Proposal for Amendment 1 of Phase 2 of UN Global Technical Regulation No. 7 (Head restraints)

Submitted by the Informal Working Group on the Phase 2 of UN Global Technical Regulation No. 7

The text reproduced below was prepared by the experts of the Informal Working Group (IWG) on UN Global Technical Regulation No. 7, Phase 2 (GTR7-PH2) and proposes provisions on head restraints. The modifications to the existing text of the UN Global Technical Regulation No. 7 (ECE/TRANS/180/Add.7) are marked in bold for new or strikethrough for deleted characters.

Figure 1-1
Goniometry in the test procedure using apparatus that facilitate the measurement of coordinates.

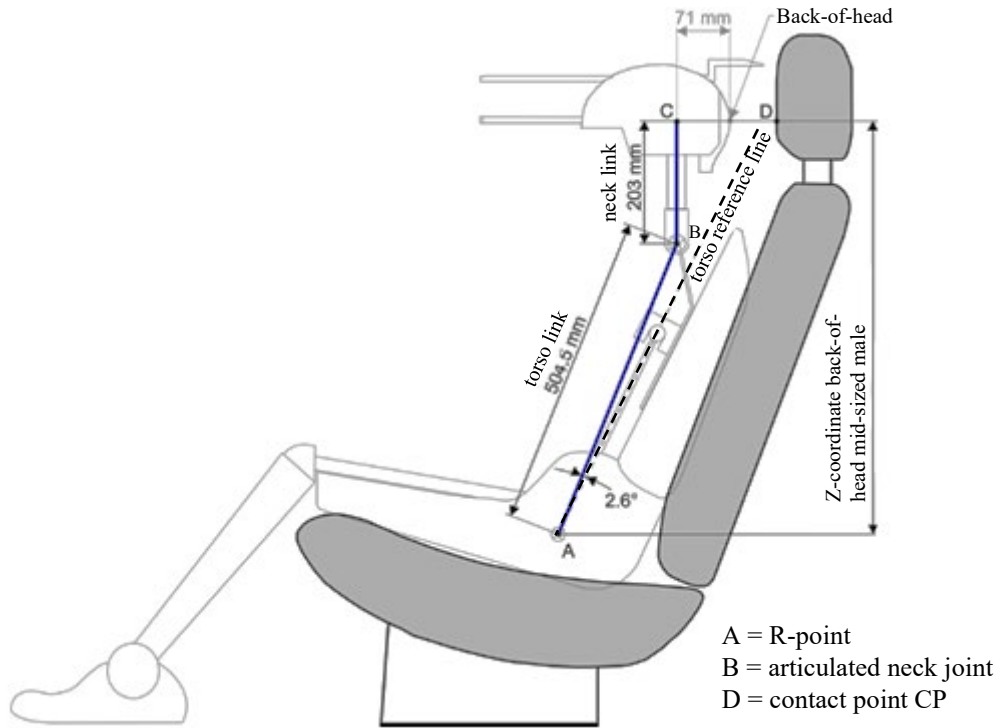
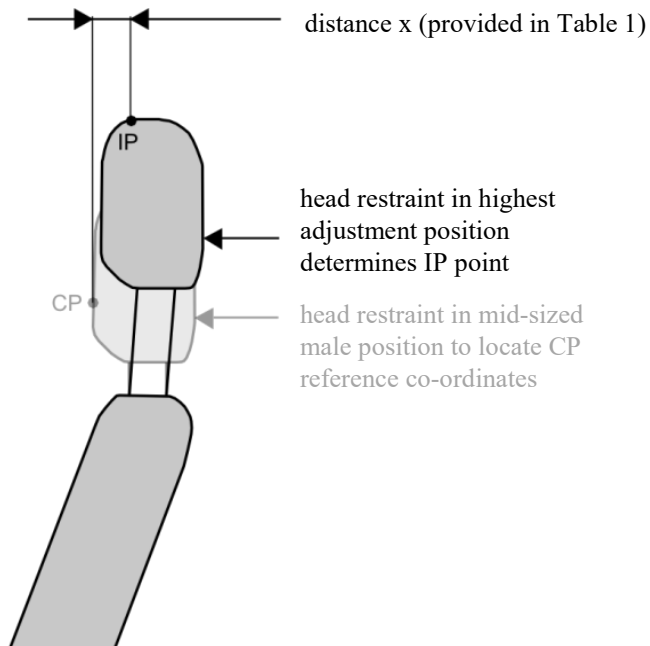
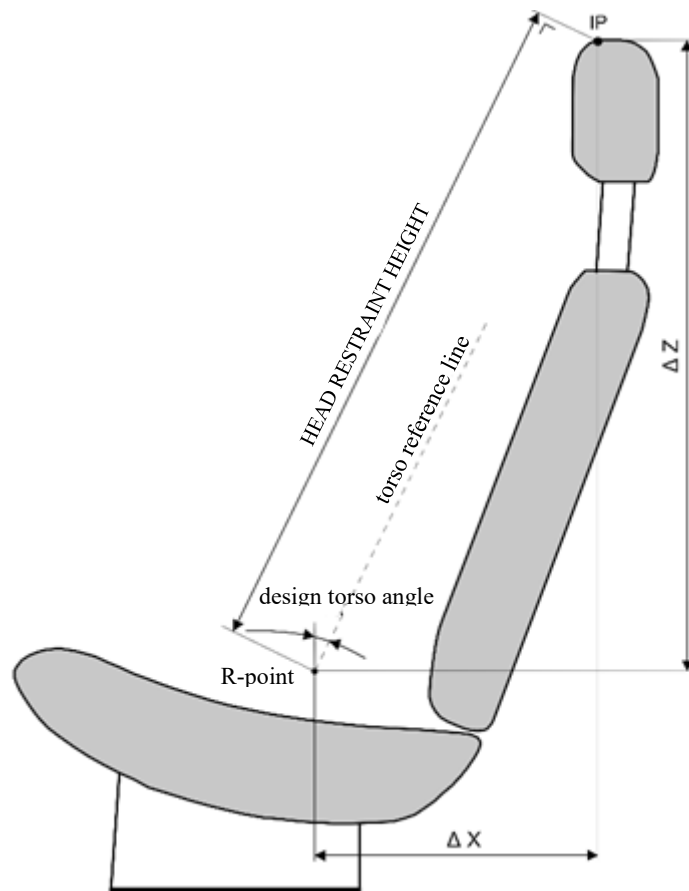
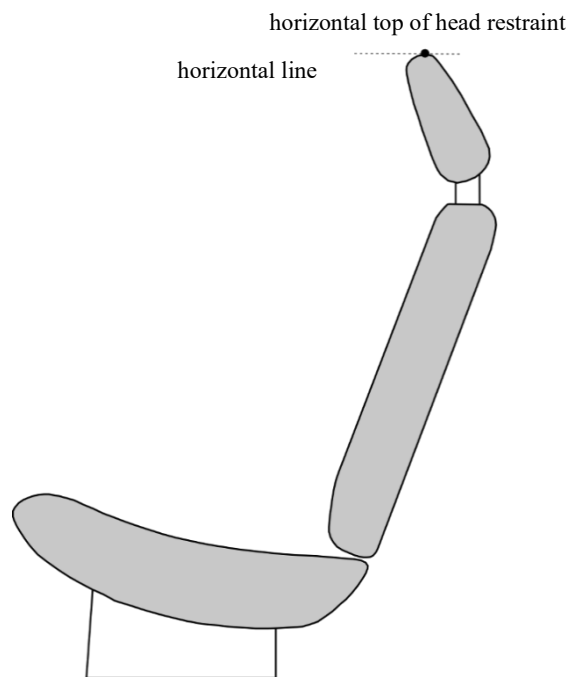
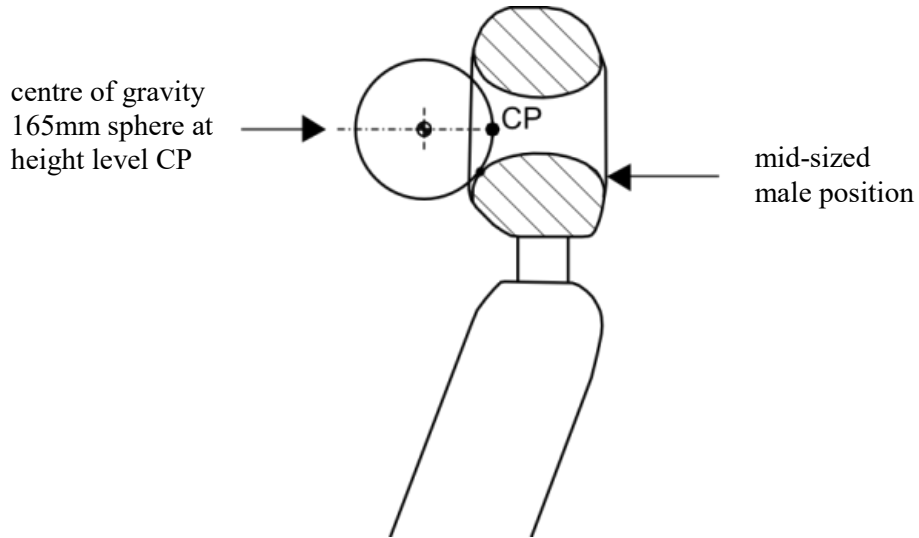
The height measurement ~~apparatus~~ consists of (see Figure 1-1): **shall be based on the use of an apparatus that facilitates the measurement of coordinates.**

The CP is defined as the intersection of a horizontal line, on the height of the Z-coordinate of the back-of-head of the mid-sized male (as given in table 1), with the front surface of the head restraint as indicated in Figure 1-1.

The IP is determined on the front surface of the head restraint as the intersection with a vertical line rearwards of CP (see Figure 1-2) at the "distance x" (as given in table 1).

The head restraint height is the distance from the R-point, parallel to the torso reference line and limited by a line perpendicular to the torso reference line intersecting IP (see Figure 1-3).

After the coordinates of the IP are determined, the highest head restraint height can be calculated by its longitudinal (ΔX) and vertical (ΔZ) distance from the R-point (see Figure 1-3), as follows:

Figure 5-2

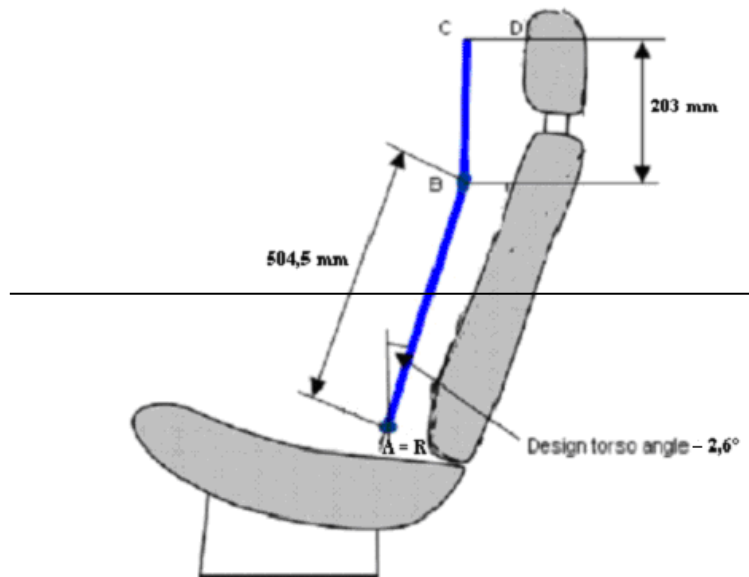
- 2.6. 2.5. Establish point D on the head restraint, point D being the intersection of a line drawn from point C horizontally in the x-direction, with the front surface of the head restraint, **see Figure 1-1 of Annex 1.**

- 2.7. 2.6. ~~Measure the distance CD. The backset is the measured distance CD minus 71 mm~~
Measure the X-coordinate of point D. The R-point backset is the difference between the X-coordinate of point D and the X-coordinate of the back-of-head of the mid-size male as given in Table 1 of Annex 1.

Figure 8-1.

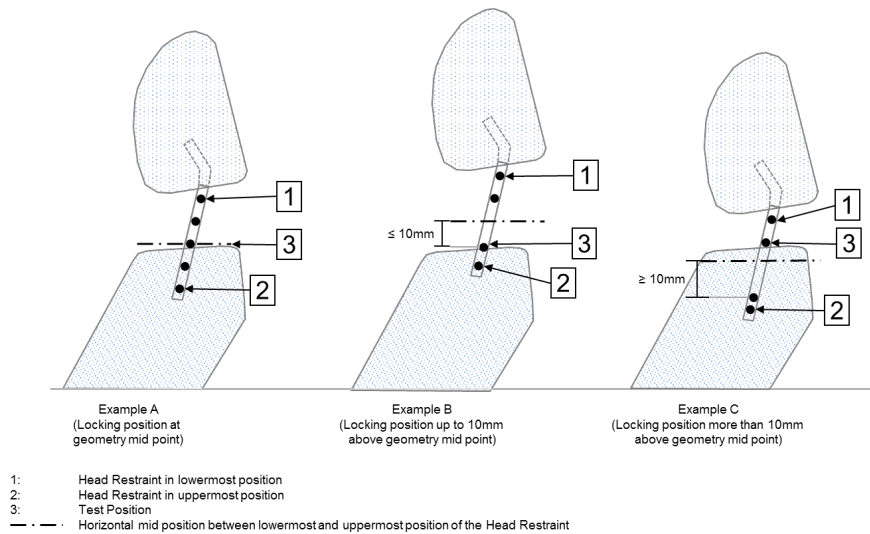
- If a locking position exists within 10 mm vertically upwards from the geometric mid-position, this shall be the test position. If no locking position exists within 10 mm vertically upwards from the geometric mid-position then the next locking position down shall be the test position. **This shall be determined from the top of the head restraint.**

When the head restraint has a locking fore-aft adjustment, it shall be in the midpoint. If a locking position exists within 10 mm horizontally forward from the geometric mid-position, this shall be the test position. If no locking position exists within 10 mm horizontally forwards from the geometric mid-position then the next locking position rearwards shall be the test position, as shown in Figure 8-1.

Figure 8-12

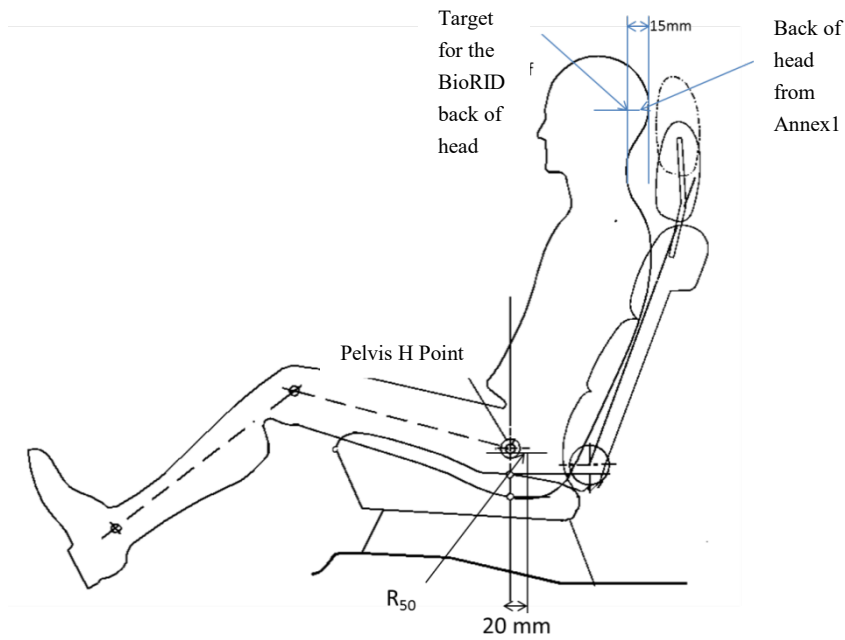
The back of the head reference position for the BioRID II is the value determined for the 50th percentile in Table 1, Annex 1 of this Regulation with reference to the specified torso angle minus 15 mm (increasing the backset as shown in figure 8-2).

- 3.2.7.6. The BioRID shall be installed such that its H-point is positioned 20 mm \pm 10 mm forward of the R₅₀-point, as shown in Figure 8-2, while keeping the pelvis angle within the range specified in paragraph 3.2.7.5. above.

Figure 9-1 8-3
Sled pulse acceleration corridor

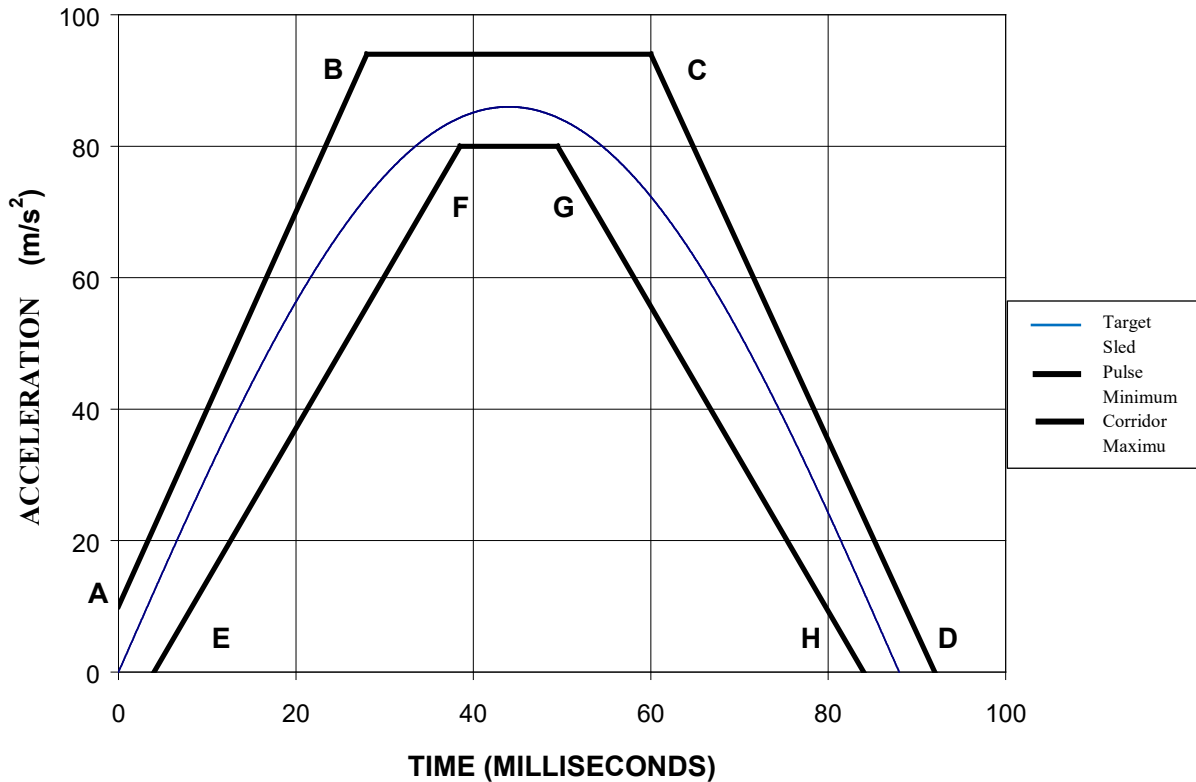
~~4.1.~~ **4.1.1.** Accelerate or decelerate the dynamic test platform to reach a delta V of 17.3 ± 0.6 km/h. All of the points on the acceleration vs. time curve fall within the corridor described in Figure 9-1 8-3 and Table 9-1 8-1 when filtered to channel class 60, as specified in the SAE Recommended Practice J211/1 (revision March 1995). Measure the maximum rearward angular displacement.

Figure 8-4
Acceleration versus time curve and Permissible Range of curve for the test set-up according to section 3.2. (The target acceleration with time expressed in milliseconds shall meet the value in the table 8-3.)

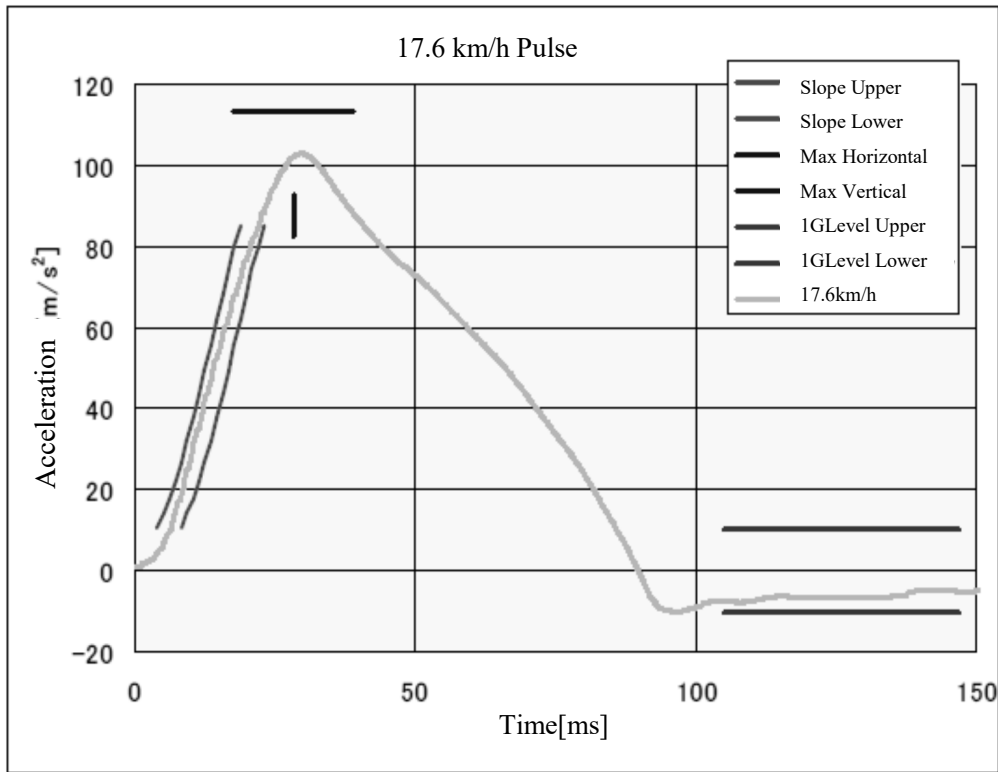
The corridors for the pulse are illustrated in Figure 8-4. The sled acceleration shall be adjusted within the corridors described in Figure 8-3 and Table 8-2 for the complete time interval from 0 to 0.15s. The sled pulse shall fulfil the requirements as specified in Table 8-3.
